Project Description / Description de projet					
	Gate Replacement	and Paving/Rempl	acement et pavage des portes		
Solicitation No./N° de solicitation	Project No./N° de projet		W.O. No./N° d'ordre de travail		
19-58077	5778		A1-011344-10-01		
Departmental Representative / représentant ministériel		Date			
Alain Leroux			January 24, 2020		
Notice:		Nota:			
shall apply and be read in conjunction with the original plans and		Cet addenda fait partie intégrale des dossiers d'appel; toutes les conditions énoncées doivent être lues et appliquées en conjonction avec les plans et les devis originaux.

PROJECT		PROJECT NO.		
	NRC - Gate Replacement & Paving - Sandy Cove		NRC: 5778	MCA: 19-543
DESCRIPTION		DATE		
	Addendum 3 - Civil Clarifications			Jan 24, 2020

-	SCALE: 1:250 E-DRM/GDD-E:	
	drawing no. C-1	00
	project number 536	
	date Tender NADINE MERKLEY PWGSC Project Manager Admi	 inistrc
	date 2019-08-29	
	date 2019-08-29 drawn NM date 2019-08-29

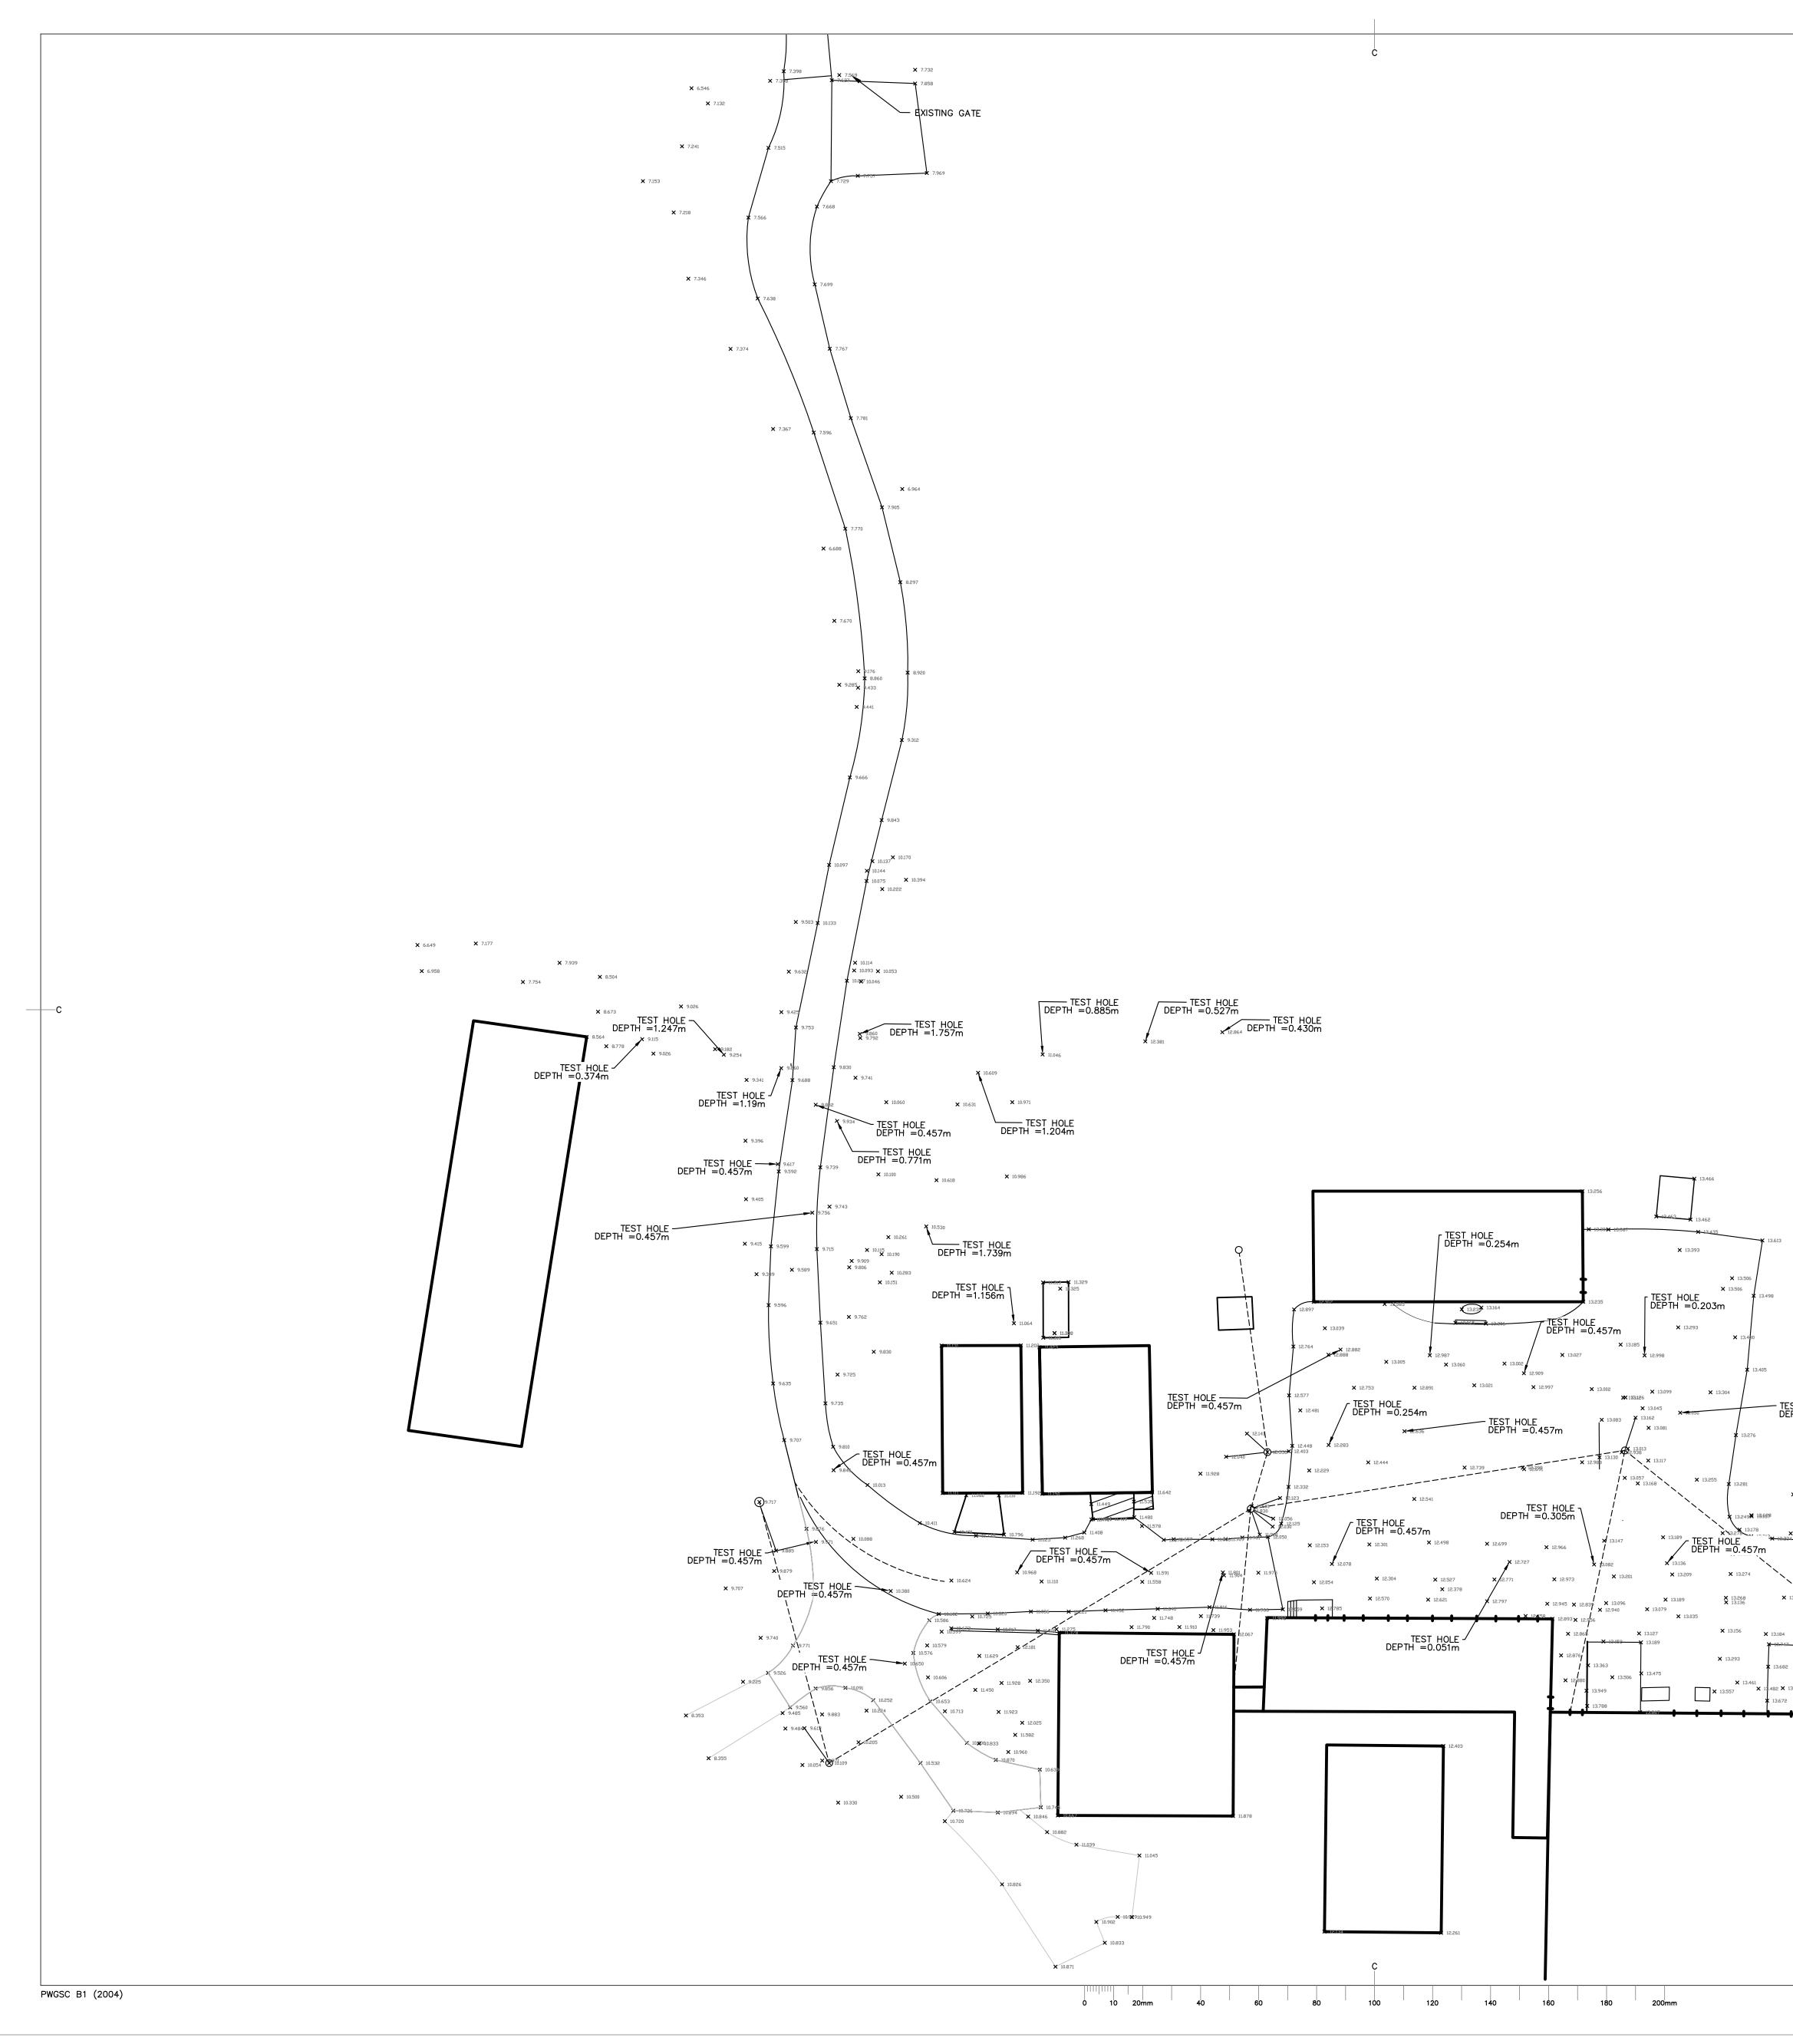
- a. The Contractor is to include into their bid the price of breaking/removing rock where the specified depth of subgrade & asphalt for the parking lot/driveway cannot be achieved otherwise. Ensure this price is broken out from the total cost for clarity.
- b. The Contractor is to include into their bid the price of breaking/removing rock where the specified depth of trench for the new electrical/communications conduits cannot be achieved otherwise. Ensure this price is broken out from the total cost for clarity.
- c. A sampling of additional test holes has been dug for information at locations of the new light pole, card reader, gate poles, and conduit trench; see the revised Drawing C-100 attached to the end of this addendum. The Contractor shall use this information to create accurate bids according to the previous items in this addendum.
